Model Error Resolution Document

INITIATION

1. Originator: Kevin G. Mon	2. Date: 4/4/2008	3. ERD No. ANL-EBS-MD-000003 ERD01
4. Document Identifier: ANL-EBS-MD-000003 REV 03	5. Document Title: General Corrosion and Localized Corrosion of Waste Package Outer Barrier

Figure 6-2. Waste Package and Drift Wall Temperature and Relative Humidity Ranges

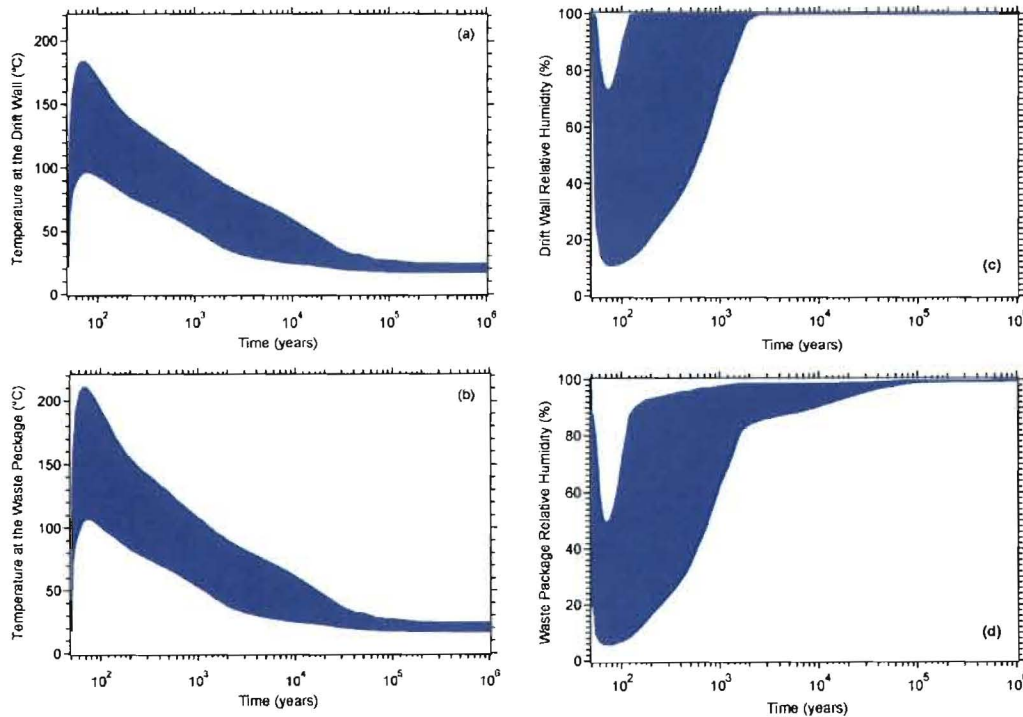
- TBV-8527 is on the use of results from *Multiscale Thermohydrologic Model* (SNL 2007 [DIRS 181383] which is now replaced by SNL 2008 [DIRS 184433]) in *General Corrosion and Localized Corrosion of Waste Package Outer Barrier* (SNL 2007 [DIRS 178519]). Figure 6-2 of *General Corrosion and Localized Corrosion of Waste Package Outer Barrier* (SNL 2007 [DIRS 178519]) is changed as shown below. The sources for Figure 6-2 are changed to "SNL 2008 [DIRS 184433], Figures 6.3-76[a] and 6.3-81[a]" and the graphics are changed to be more consistent with those shown in the current *Multiscale Thermohydrologic Model* (SNL 2008 [DIRS 184433]).

Source: SNL 2008 [DIRS 184433], Figures 6.3-76[a] and 6.3-81[a].

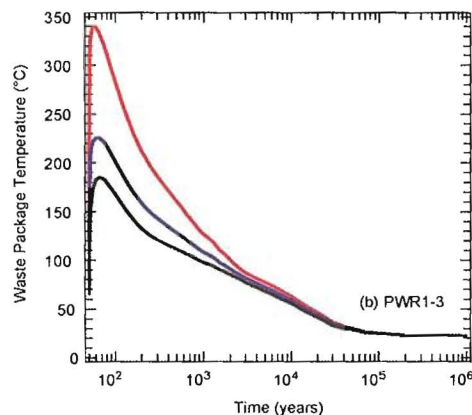
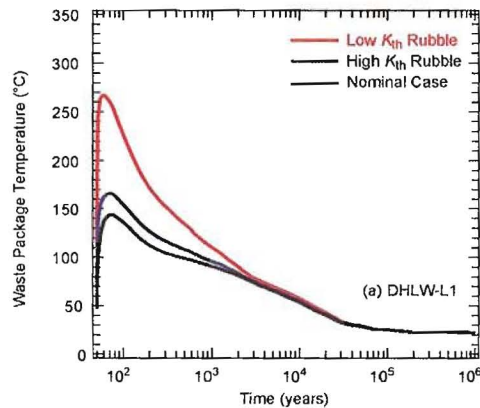
Figure 6-3 of *General Corrosion and Localized Corrosion of Waste Package Outer Barrier* (SNL 2007 [DIRS 178519]) is changed as shown below. The source for Figure 6-3 is changed to "SNL 2008 [DIRS 184433], Figure 6.3-82[a]" and the graphics are changed to be more consistent with those shown in the current *Multiscale Thermohydrologic Model* (SNL 2008 [DIRS 184433]).

Source: SNL 2008 [DIRS 184433], Figure 6.3-82[a].
